Summary of Items Discussed in 4/2020 APSEC Discussion Forum on 26 November 2020

Figure 3: AC Platforms in combined Balcony and UP (one AC platform is also acceptable)

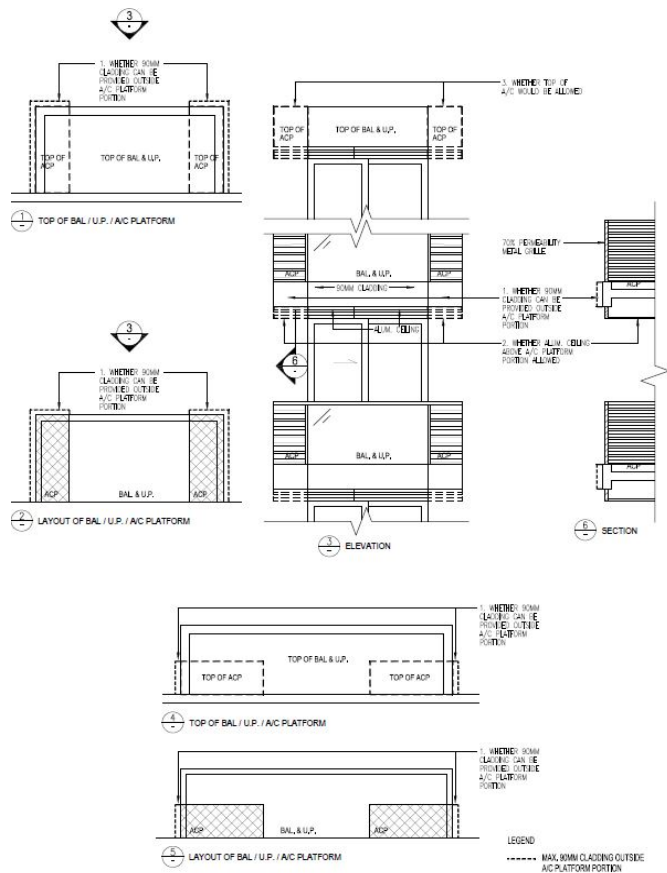
<p>1. Grease trap room and/or sump pump room for F&B facilities; and 2. Irrigation water tank and plant room for greeneries.</p>	
<p>2.</p>	<p><u>AC Platform Combined with Balcony/UP</u></p> <p>Where AC platform is to be combined with Balcony and/or UP as per Appendix B of the CoP on Design for Safety - External Maintenance 2019 (“the DfS Code”), it is not uncommon that such AC platform is to be designed as an integral part of the Balcony/UP so as to achieve a coherent and decent outlook with incorporation of the following features:</p> <ol style="list-style-type: none"> 1) Same external finishing treatment, such as with 90mm thick cladding and/or architectural features along the outer perimeter of the combined balcony/UP/AC platform; 2) Aluminium ceiling above the whole combined balcony/UP/AC platform; and/or 3) For the uppermost combined balcony/UP/AC platform, having a top roof/cover over the whole combined feature. <p>Please refer to the following diagrams illustrating the above examples, which configurations are developed on the basis of Figure 3 in Appendix B of the Code:</p>	<p>BD had no objection in principle provided that the screen of the AC platforms could meet the requirements under Appendix B of the DfS Code and no part of any wall finishes/cladding should project beyond the site boundaries.</p>

We are of the opinion that these design/amenity features have minimal implication on the building bulk and should be considered acceptable by BD. Please confirm if our understanding is correct.

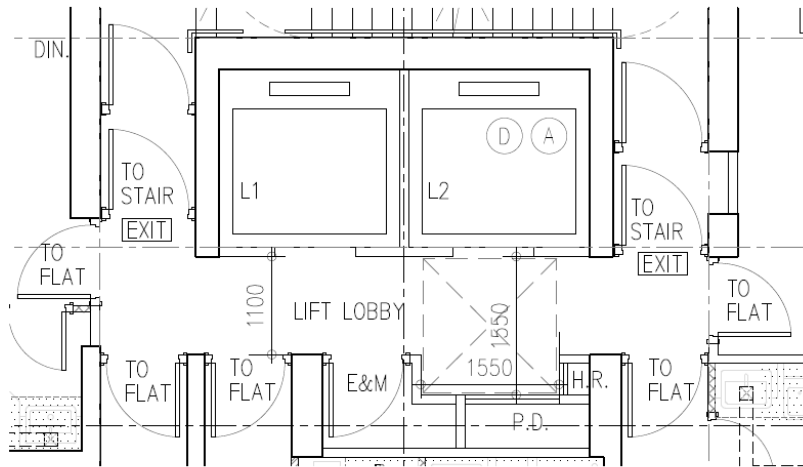
13.	<p><u>Lobby to a Fireman’s Lift</u></p> <p>Referring to Clause D11.1 of FS Code 2011, <i>“each point of discharge from</i></p>	<p>As regards the sketch plan provided, BD advised that AAP’s</p>

a fireman's lift to the floor served..., should be through a lobby having a floor area of not less than 2.25 m² and a minimum dimension of 1.5m”.

The layout below providing a 1.5m x 1.5m clear space in front of the fireman's lift door would satisfy this requirement, please advise if our interpretation is correct.

interpretation was correct provided that other requirements including the provision of MoE and access for persons with a disability were complied with.

PLAN OF SET BACK FOR SERVICE LANE OF REDEVELOPMENT (SCENARIO 2)
(CLASS A SITE)

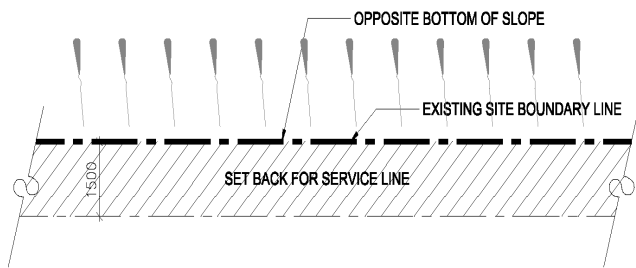
<p>Would BD please confirm if our understanding is correct.</p>	
<p>15.</p>	<p><u>Service Lane</u></p> <p>B(P)R 28 requires that every domestic building shall be provided with a service lane, would BD please confirm if the following scenarios are considered acceptable:</p> <p><u>Scenario 1</u></p> <p>When there is an existing service lane of 1.8m wide adjoining the site, the building on the site is to set back 600mm from the lot boundary such that 1.5m width measured from the centreline of the service lane to the building on the site is provided. Upon development of the opposite site, a lane of not less than 3m wide could be achieved.</p>  <p><u>PLAN OF EXISTING SERVICE LANE</u> (SCENARIO 1) (CLASS A SITE)</p> <p><u>Scenario 2</u></p> <p>When there is no existing service lane and the site is abutting an existing</p>	<p>BD advised that, pursuant to paragraph 10 of PNAP APP-73, the long-term objective was that upon full development of abutting sites, a lane would be direct and have an unobstructed width of not less than 3m. In this connection, if there were sites abutting on both sides of the lane, a setback of 1.5m on each side would be acceptable, otherwise a setback of 3m should be provided.</p> <p>For Scenario 1, if the existing 1.8m service lane was a public lane, then a setback of 600mm would be acceptable on each side. On the other hand, if the existing 1.8m service lane was a private lane (no matter the site had the right of way over such private lane), a setback of 1.5m should be provided.</p> <p>For Scenario 2, if there was no building site at the other side, then a setback of 3m should be provided.</p>

slope, the building on the site is to set back 1.5m from the lot boundary as shown in the diagram.

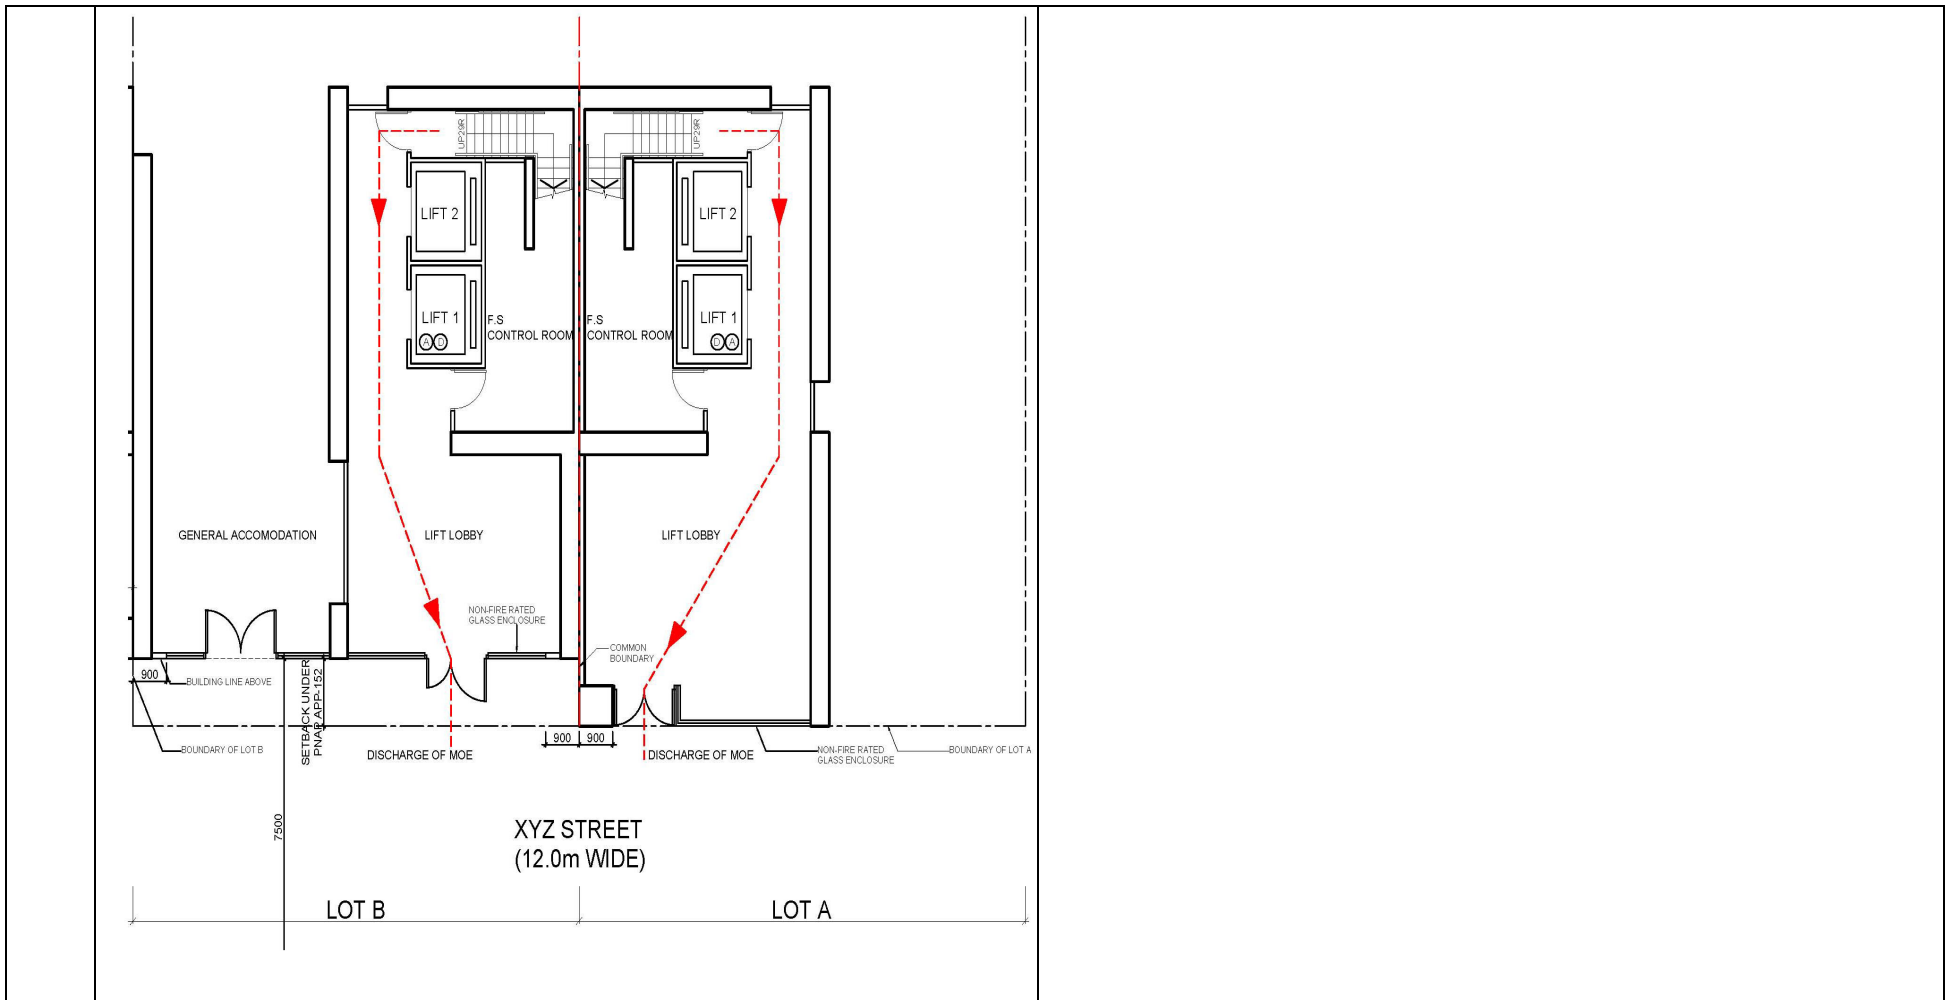
Under Code of Practice of Fire Safety in Buildings 2011 Clause 5.3, if any part of any building is within a distance of not more than 900mm from the site boundary of the adjoining site, the external walls and roofs of that part should have an FRR of not less than that of the internal elements of construction. Discharge of MOE through lift lobby to the street is acceptable and the external enclosure facing street does not require FRR

<p>construction, which is represented by “Lot A” in the diagram.</p> <p>However, for S.B.D. under PNAP APP-152, building setback is required if the street abutting the site is less than 15m. Under the aforesaid scenario a common boundary between adjoining lot is exposed at the setback portion as shown at “Lot B” in the diagram.</p> <p>Since the set back area can be regarded as Ultimate Place of Safety for Mean of Escape, the requirement under Clause C9.7 of Code of Practice of Fire Safety in Buildings 2011 shall not be applicable to this scenario and therefore no FRR construction is required for the glass screen wall except the 900mm fire rated separation between two different lots.</p>	
---	--

BD advised that the requirements under Clause C9.7 of FS Code 2011 were not applicable to “Lot A” under the specified situation but applicable to “Lot B” according to AAP’s sketch.
